Docket: J-36(M)  
Project: S-8

November 14, 1962

Charles D. Luke, Chief  
Criticality Evaluation Br.

UNITED NUCLEAR (CHEMICAL DIVISION), DOCKET 70-35

Graphs of table IV, p. 15, TID-7019

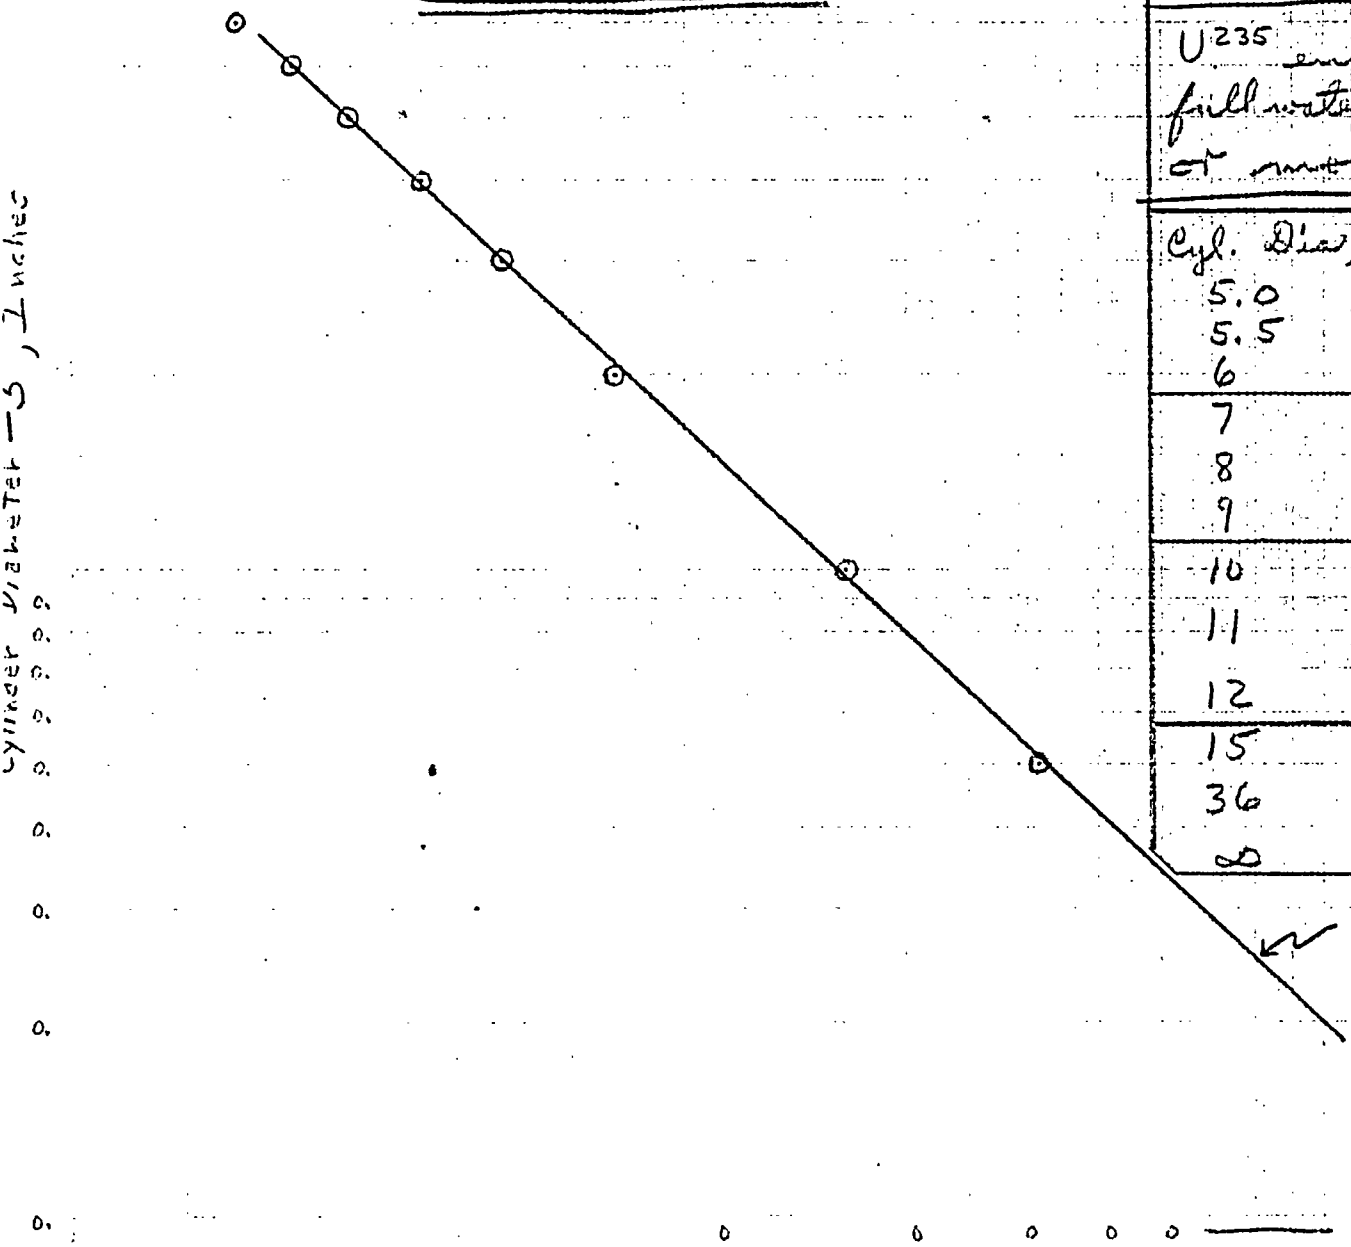
We had recommended against the 5.25" ID shipping container as exceeding the 5" ID maxima for an infinite cylinder for uranium solutions or uranium compounds (maxima density 5.2 g/l), for any moderation, any enrichment and full water reflection (reference 2).

Mr. Swallow (reference 3) stated he had taken credit for cylinder height, as permitted by Table IV, TID-7019. We accept this table as a criterion for the materials described in paragraph 1 above, and agree that 5.25" ID is a safe diameter for the 36 1/2" height.

for 5.25 in dia cyl.  
 $H = 70 + 1.5 = 71.5$  in

To confirm accept. size of 5.25 in  
dia. cyl. of height 36.5 in

$$D_s = 5.7 \left( \frac{5.0}{5.4} \right) = \underline{\underline{5.27 \text{ in}}}$$
